Wisconsin Department of Transportation

Proposal #06: 1060-27-71, WISC 2025596
I-94 East West, West Leg
70th Street to Zablocki Drive
IH 094
Milwaukee County

This is Addendum No. 02, which provides for the following:

ADDENDUM NO. 02

Addendum No. 02
ID 1060-27-71
Revised Sheet 5
August 28, 2025

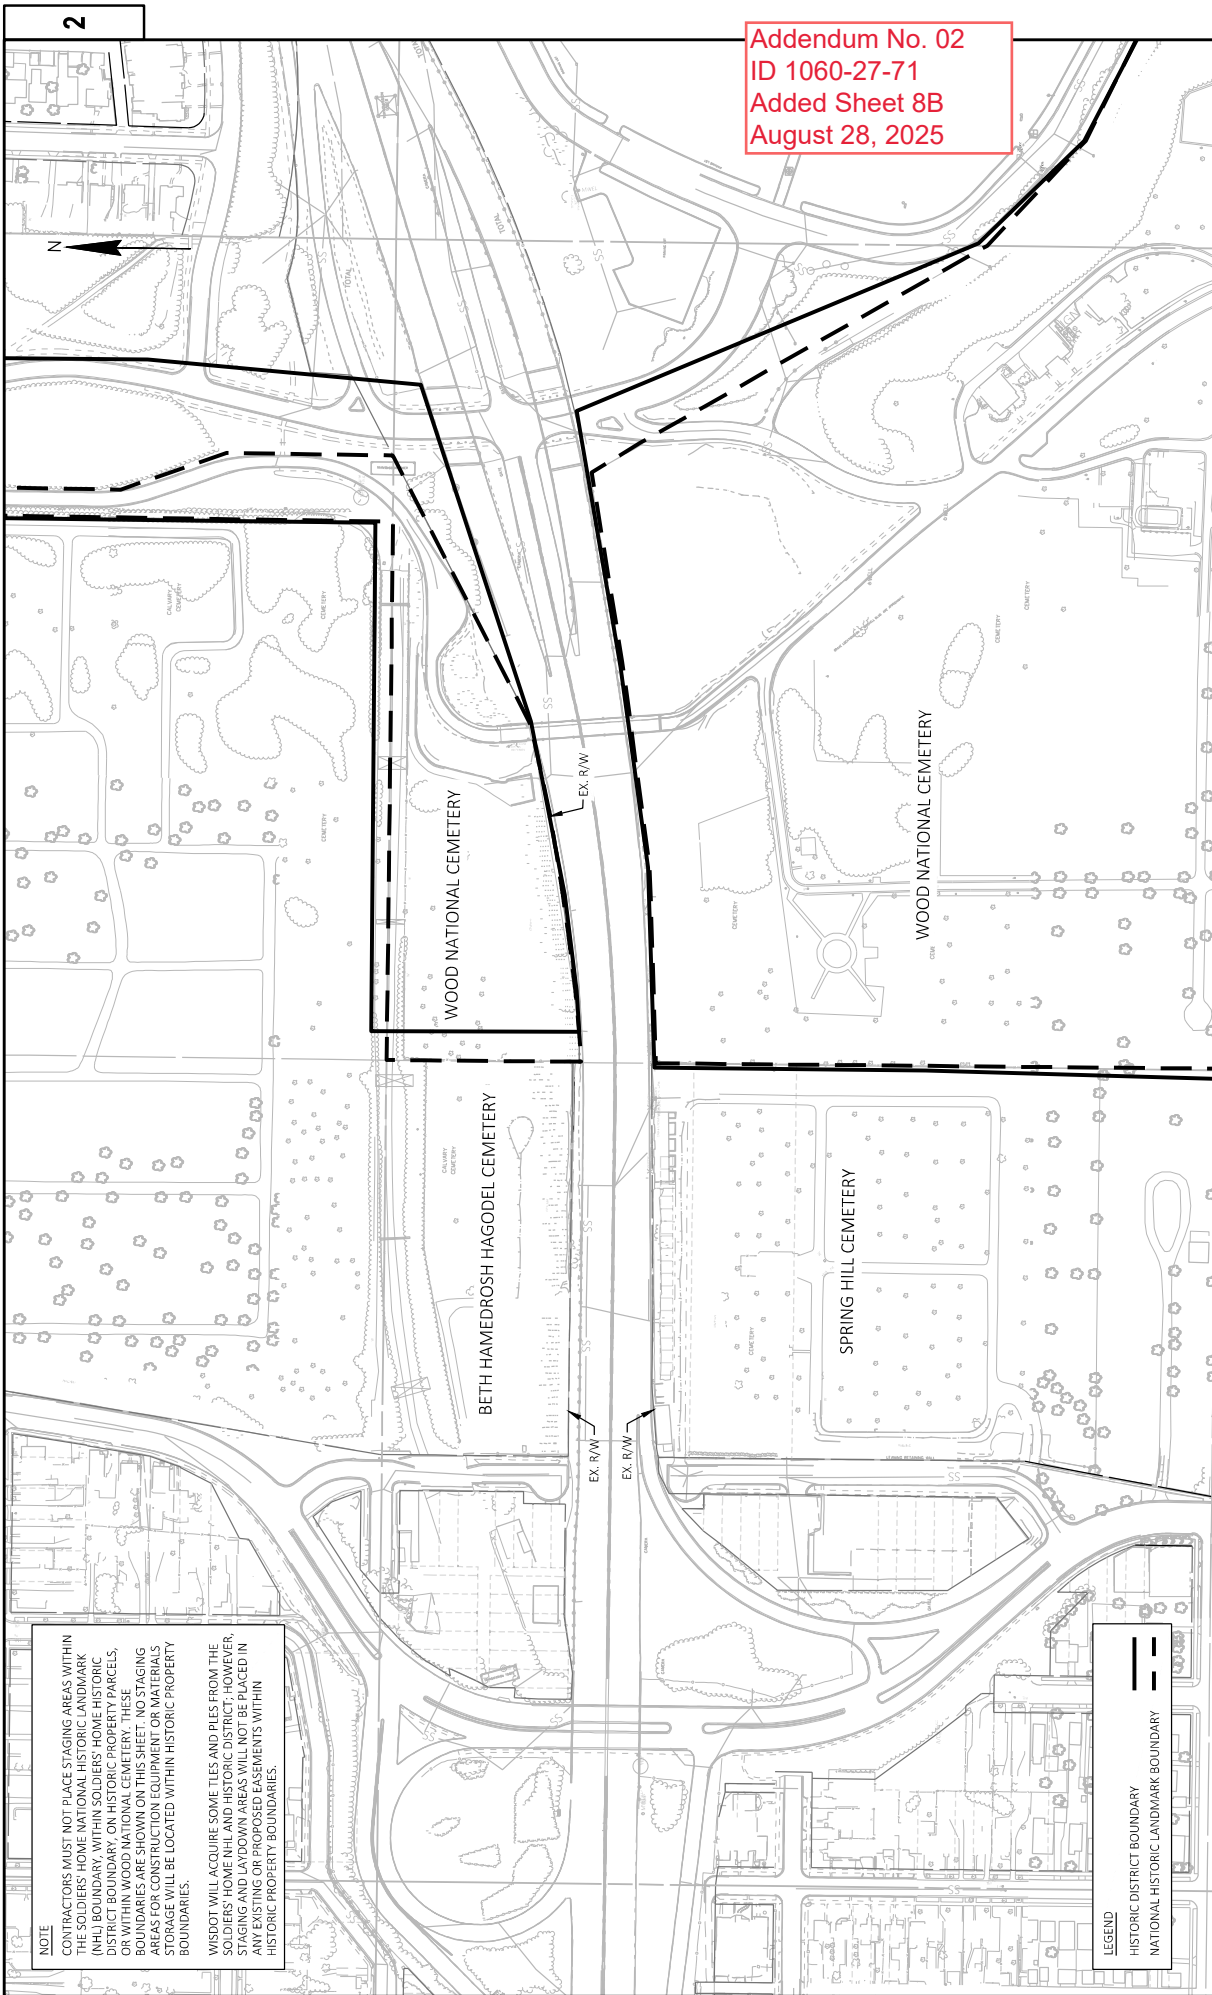
Revised Plan Sheets	
Plan Sheet	Plan Sheet Title (brief description of changes to sheet)
5	General Notes: Revised asphalt mixes and layers
35	Typical Finished Sections: Revised asphalt mixes and layers for Ramp FMD
132	Plan Details: Revised asphalt mixes and layers in legend
400	Hawley Road Watermain Plan: S Dana Ct Hydrant Location Updated
614	City Underground Conduit Plan 68 th ST-1: Updated Construction Note
615	City Underground Conduit Plan 68 th ST-2: Update Construction Note Added MH
616	City Underground Conduit Plan 68 th ST-3: Updated Construction Note
617	City Underground Conduit Plan 68 th ST-4: Updated Construction Note
618	City Underground Conduit Plan Hawley RD-1: Updated Construction Note
619	City Underground Conduit Plan Hawley RD-2: Updated Construction Note
620	City Underground Conduit Plan Hawley RD-3: Updated Construction Note
621	City Underground Conduit Plan Hawley RD-4: Updated Construction Note

ALL TYPES OF HMA PAVEMENT SHALL BE CONSTRUCTED WITH THE FOLLOWING LAYERS:

PLAN DETAIL AND TYPICAL SECTION LEGEND CALLOUT	HMA PAVEMENT	TOTAL LAYER PAVEMENT THICKNESS	LAYERS
AP02	4 HT 58-28 H 3 HT 58-28 S 3 HT 58-28 S	7-1/2"	2" UPPER 2-3/4" LOWER 2-3/4" LOWER
AP04	4 HT 58-28 H 3 HT 58-28 S 3 HT 58-28 S	7"	2" UPPER 2-1/2" LOWER 2-1/2" LOWER
AP05	4 HT 58-28 H	2-1/2"	2-1/2" UPPER

TRAFFIC CONTROL - STAGE 1B

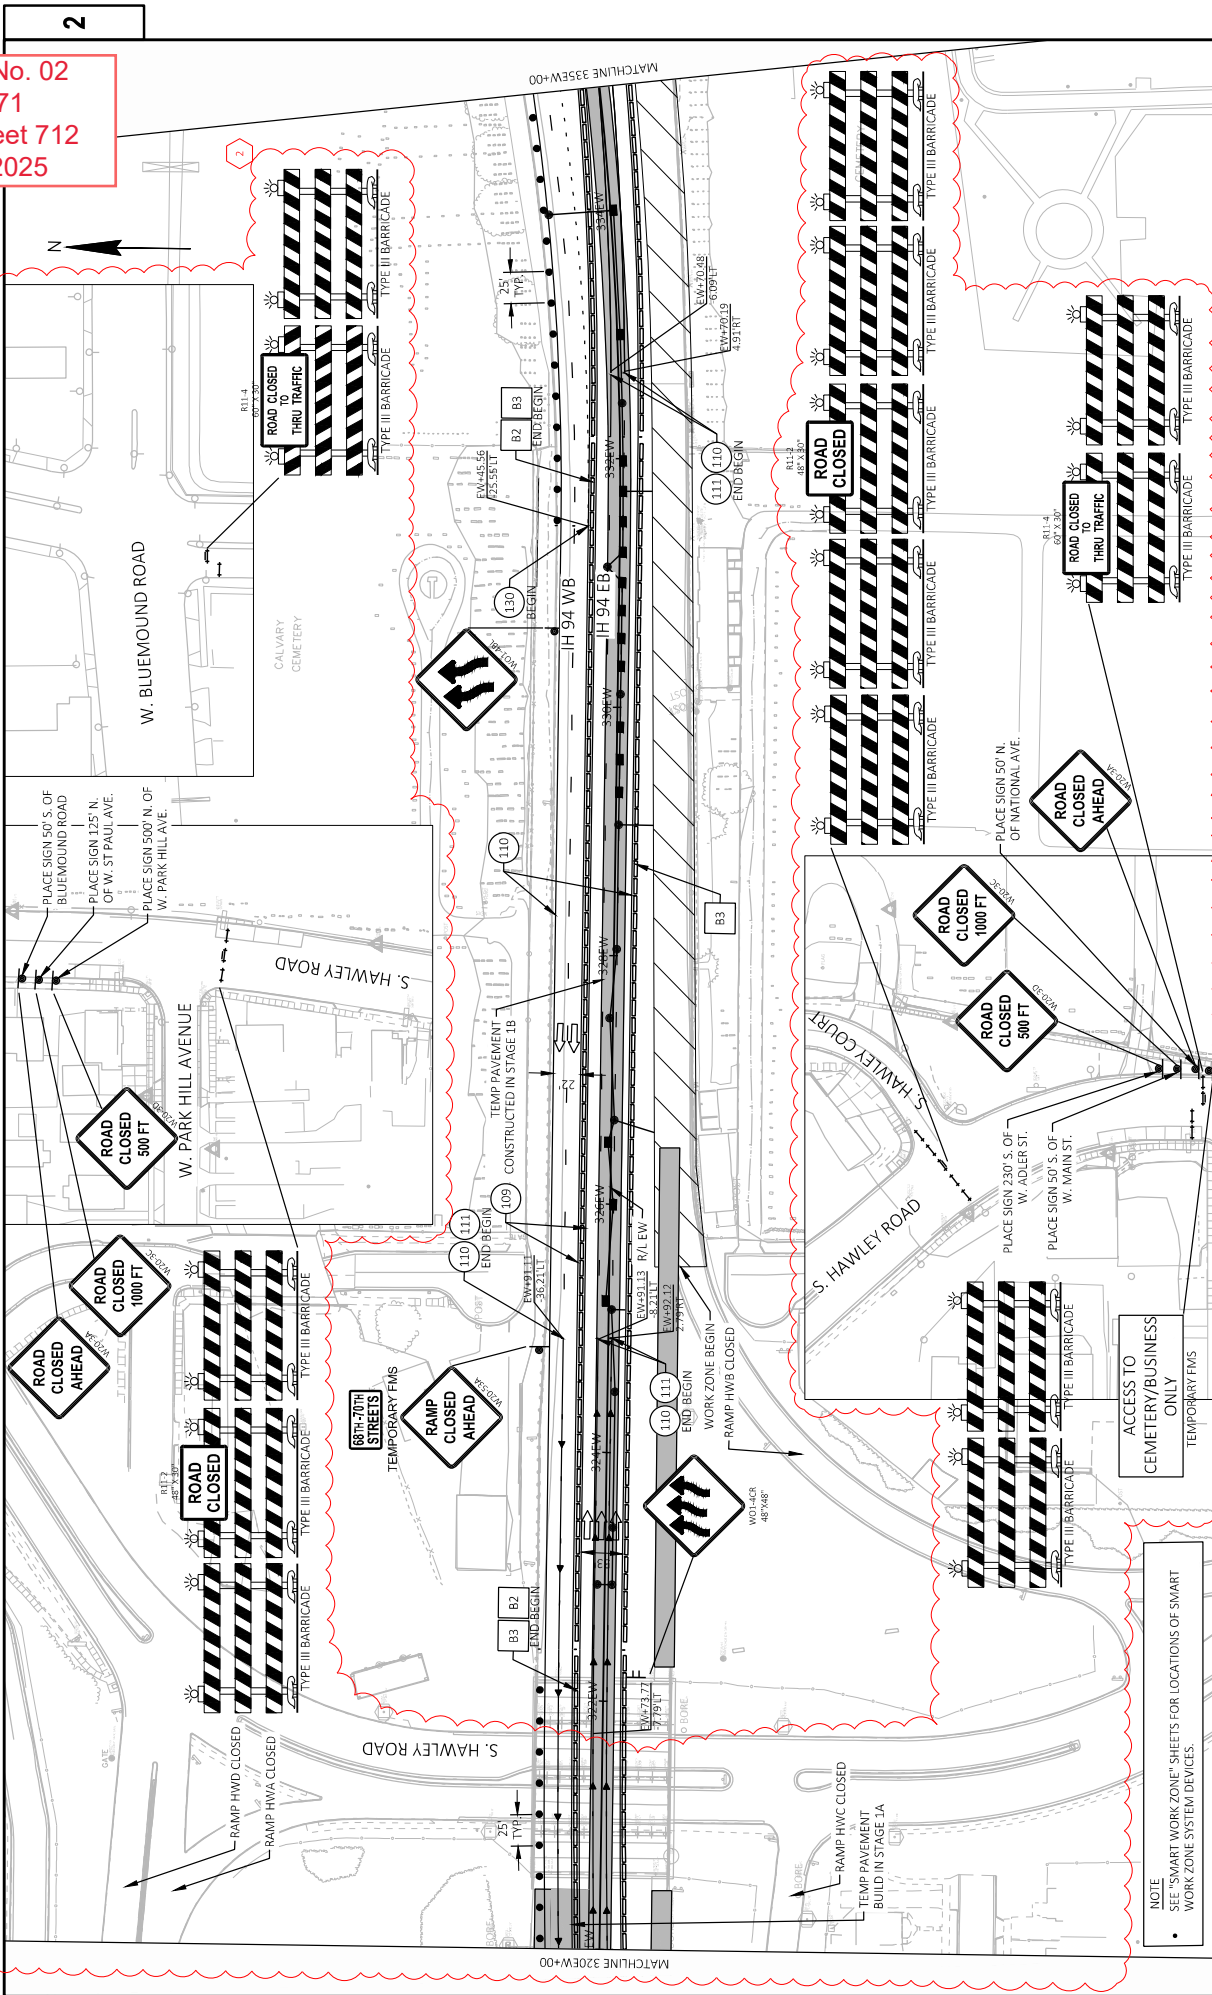
697	Traffic Control – Stage 1B: Revised for Hawley Road Closure Update
712	Traffic Control – Stage 2A: Revised for Hawley Road Closure Update
727	Traffic Control – Stage 2B: Revised for Hawley Road Closure Update
742	Traffic Control – Stage 2C: Revised for Hawley Road Closure Update
931	Misc Quantities: Revised Asphaltic Pavement Items table
1030	Misc Quantities: Revised Station and Quantity
1079	Misc Quantities: Added Undistributed Hydro Excavation Quantity
1142	Misc Quantities: Revised Quantities for MHs and Conduit
1151	Misc Quantities: Revised Quantities for Hawley Road Closure Update
1152	Misc Quantities: Revised Quantities for Hawley Road Closure Update
1153	Misc Quantities: Revised Quantities for Hawley Road Closure Update
1156	Misc Quantities: Revised Quantities for Hawley Road Closure Update
